RE: Synergy Recycling of Central Florida, LLC
US EPA I.d. No. FLR 000 053 611; FDEP Permit No. 292753-HO-004
Used Oil Permit Revision 1 Response to April 20, 2011 Notice of Deficiency

Notice of Deficiency - 1

ATTACHMENT April 20, 2011 Synergy Recycling of Central Florida, LLC Winter Haven, Florida EPA I.D. No. FLR 000 053 611 Permit No. 292753-HO-004 Notice of Deficiency

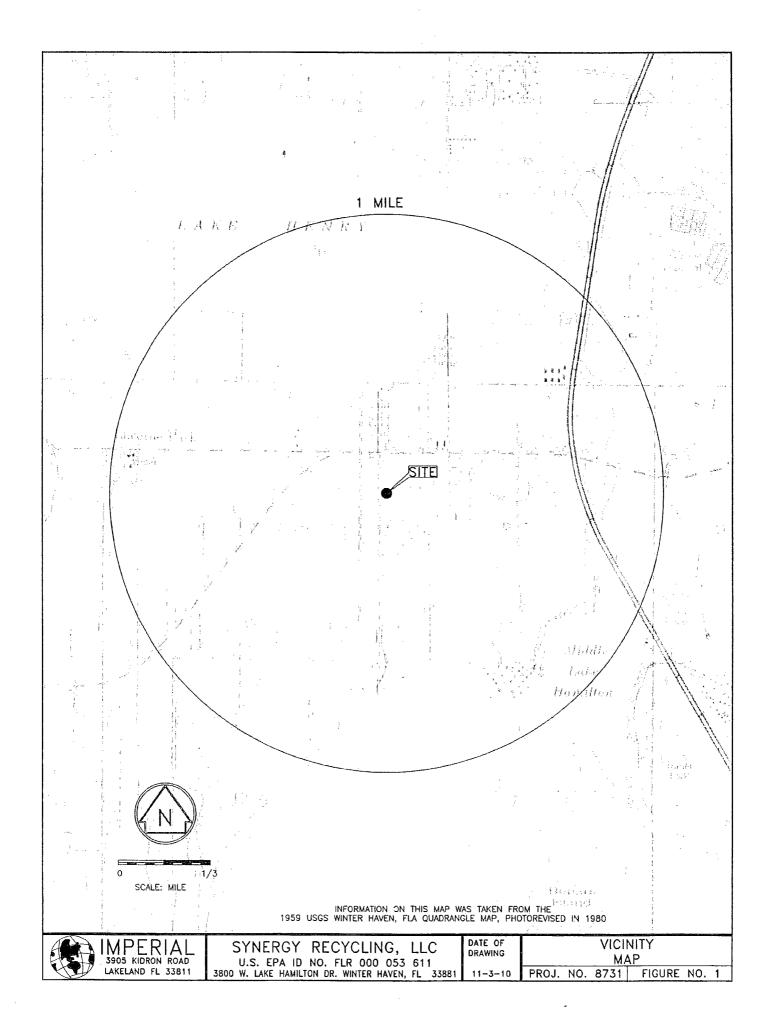
- 2. Figure No. 1 Vicinity Map is not legible. Please provide a legible copy.
- 3. Figures No. 2, 5, 6, 7, 8, 9, 10, 12 show a Proposed 25,000 Gallon AST and a Proposed Tank Farm Containment. The figures should be updated to reflect that the proposed AST has been installed and the secondary containment has been constructed and are no longer proposed.

- 2. The vicinity map had copied lightly; there are no changes in the vicinity map from the initial permit application submittal before the submitted modification.

CLOSURE PLAN
PROJ. NO. 8731 FIGURE NO. 12

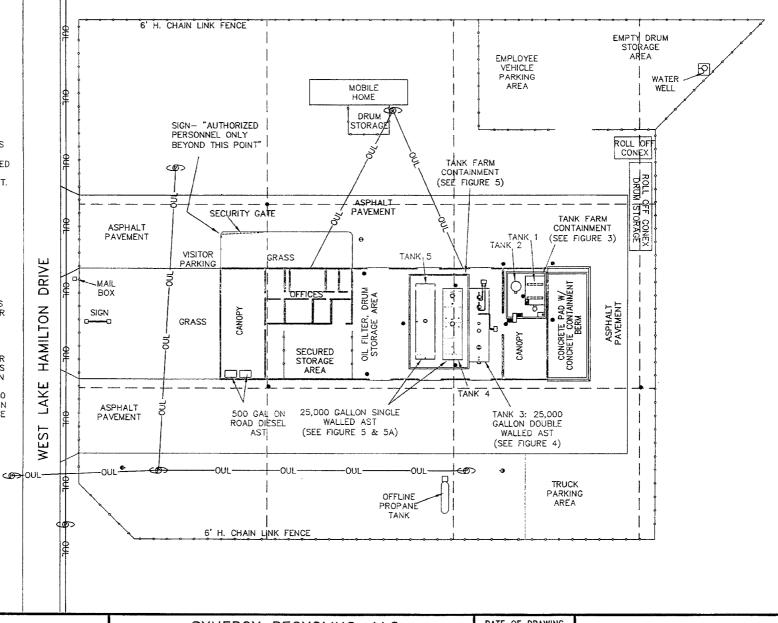
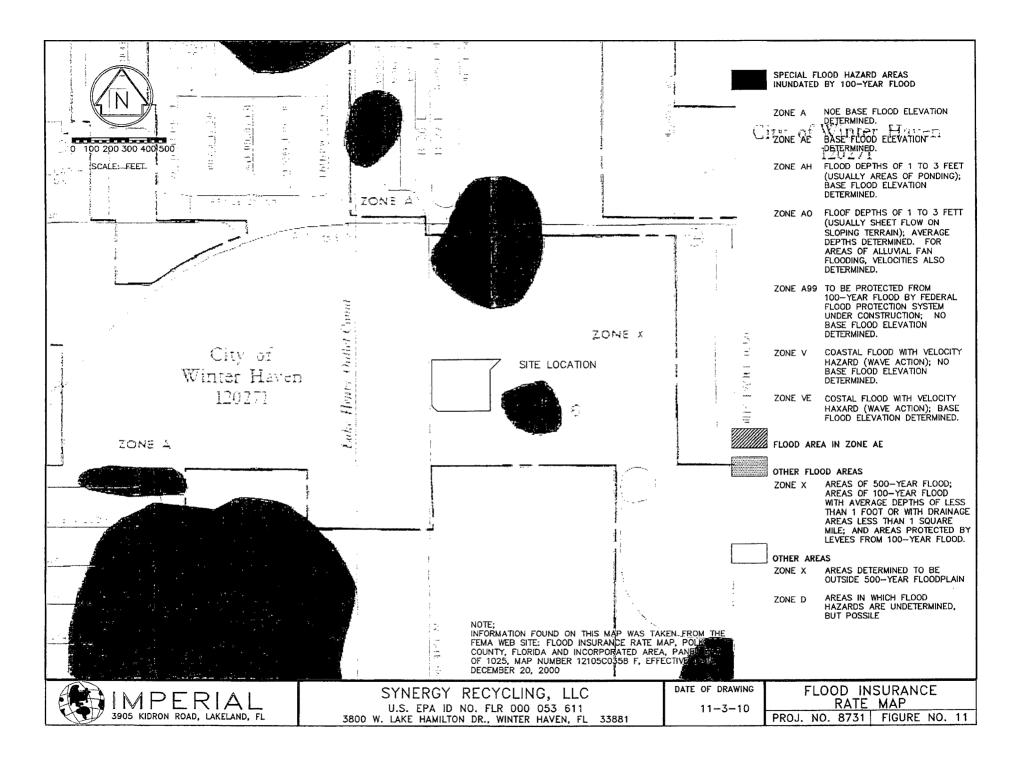
- 4. The proposed secondary containment arrow in Figures No. 2, 6, 7, 8, 9, 10, and 12 does not point to the precise location of the secondary containment. The figures already show secondary containment around the two 25,000 gallon single walled tanks. It is not clear if the proposed secondary containment will be around the two single walled and the double walled tanks or just the single walled tanks

- 3. At the time of the application Tank 5 (25-kgallon) and the containment structure were proposed. The submitted Figures illustrated the two single walled 25-kgallon tanks (Tanks 4 and 5) being surrounded by the containment structure. Figures have been revised to include Tank numbers.
